# **Objection to Network Rail (Cambridge South Infrastructure Enhancements) Order**

## **Statement of Case**

**Figure 2**

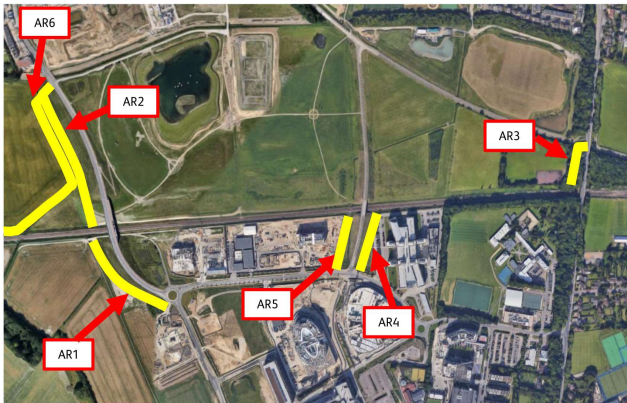
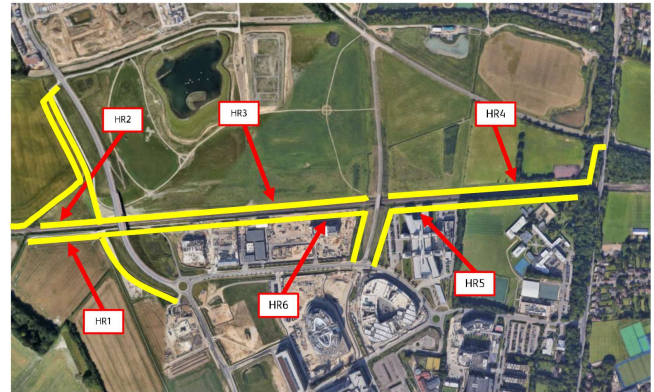
2.5 So it is to be welcomed that no construction access roads will be built in Hobson's Park – see Figures 2 and 3 below (copied from Consultation stakeholder information Pack).

**Figure 5**

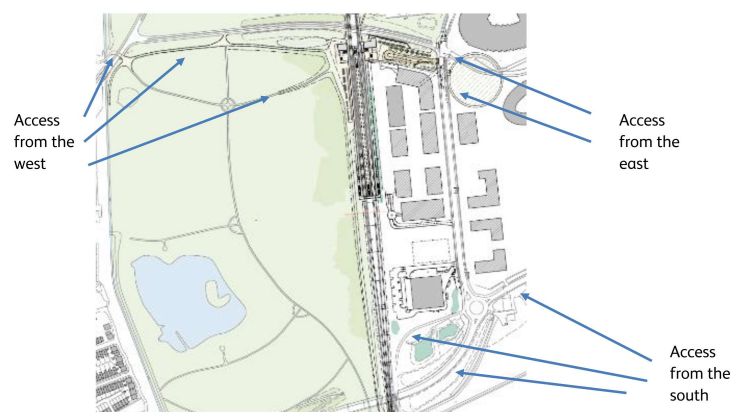
2.7 We understand that the footpath leading into the new station from the west will need some development – see Figure 5 (copied from Consultation stakeholder information Pack) below.

**Figure 6**

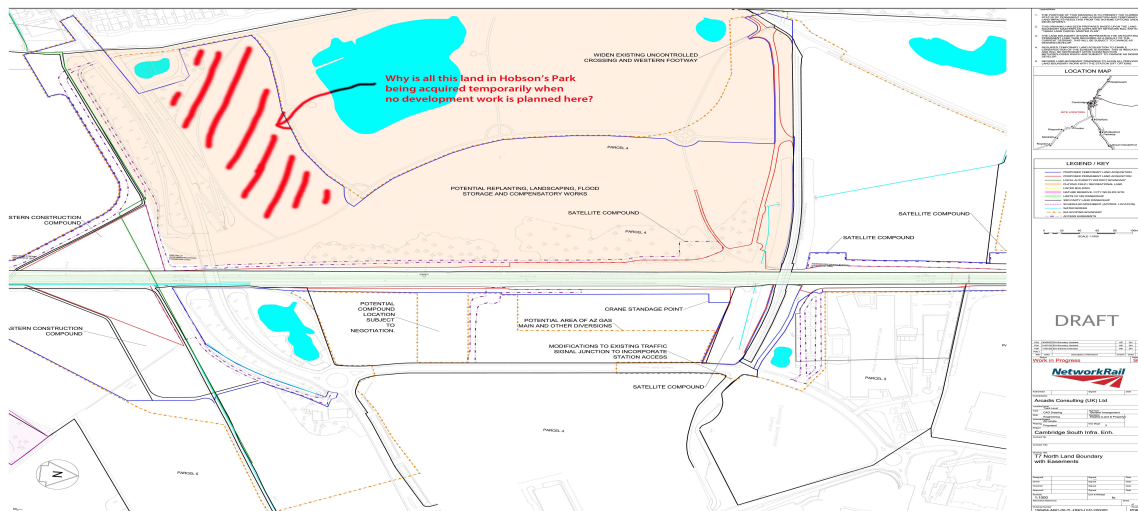
2.9 However, we were very surprised to see that Network Rail propose to acquire what looks to be well over 50% of Hobson's Park during the construction phase. See Figure 6 below (Appendix A to Consultation). (Note that in this diagram North is to the right.)

2.10 In particular we disagree that the red hatched area shown below, which includes pedestrian access from Addenbrookes, should be made off limits to pedestrians during the construction phase.

2.13 Whilst some tree planting near the station sounds desirable, there is no obvious need for large-scale landscaping next to the Addenbrookes Road. Why build up the high ground from Addenbrookes Road into the Park? It is not acceptable to move excavated spoil to that part of the park which is next to the Addenbrookes Road just to dispose of it.

2.14 We do not accept that the access to Hobson's Park from Addenbrookes Road should be closed during the construction period. We understand that Network Rail may need to close footpaths temporarily, but diversions need to be put in place if this occurs. The footpath access from Addenbrookes Road is the only access through the southern boundary of Hobson's Park, and there is no access to the eastern boundary (until the station is completed). So the southern access is important, now, during construction, and after construction.

2.15 If Network Rail needs to temporarily close the Addenbrookes Road access to undertake landscaping work in Hobson's Park, another access from Addenbrookes Road will be required for the duration, unless the closure were very short (e.g couple of days).

“The additional temporary land-take in Hobson's Park is to allow space for the sorting and storage of excavated material. In the area you show in Appendix A we propose landscaping which will extend the existing higher ground levels further into the Park; the height of these will be no higher than existing landforms. This will unfortunately prevent public access via the "zigzag" path and steps during the construction period. As you can appreciate, we would only seek to temporarily limit access for safety reasons to avoid any conflict between construction operations and users of the Park. A portion of the steps may need to be replaced/removed as part of our landscaping proposals. At this stage of design I am not able to tell you much more but we will engage with yourselves and the City Council once we have developed this further.”
